Submission to
Land Transport New Zealand
on
Manual for Traffic Control Devices
Volume 9: Level Crossings (draft)

BARCLAY TRAFFIC PLANNING

November 2007

FIGURE 2 Skewed crossing types

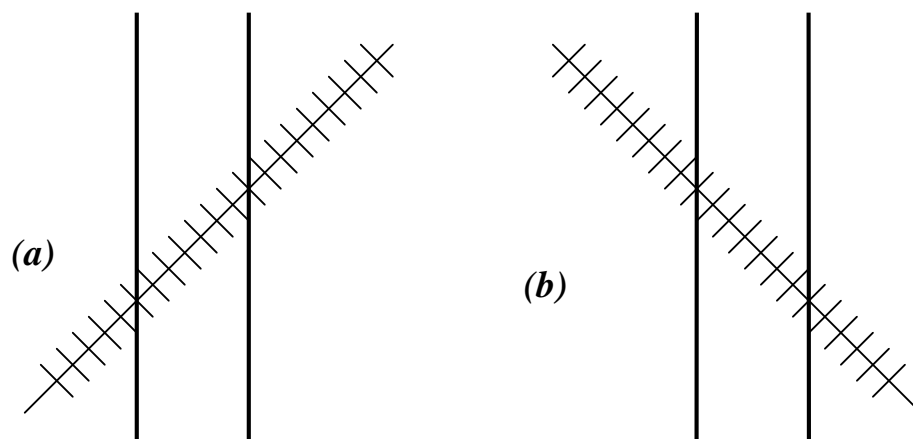
As with intersections, drivers need adequate sight lines at rail crossings. For a clear view in both directions, the road should intersect with the rail line at an angle of between 70 and 110 degrees.

Where this cannot be achieved, the arrangement (b) in Figure 2 is to be preferred, with the acute angle on the right. This will allow drivers to check over their shoulder for trains approaching from the right.

Where the acute angle is on the left as in (a), drivers will not have a clear view of trains approaching from the left, especially in trucks or vans where the load obscures vision toward the left and rear.

The difference between the two situations needs to be recognised when determining how a crossing should be controlled. There could be a case for requiring all Type (a) crossings to be controlled by active devices such as bells and lights.
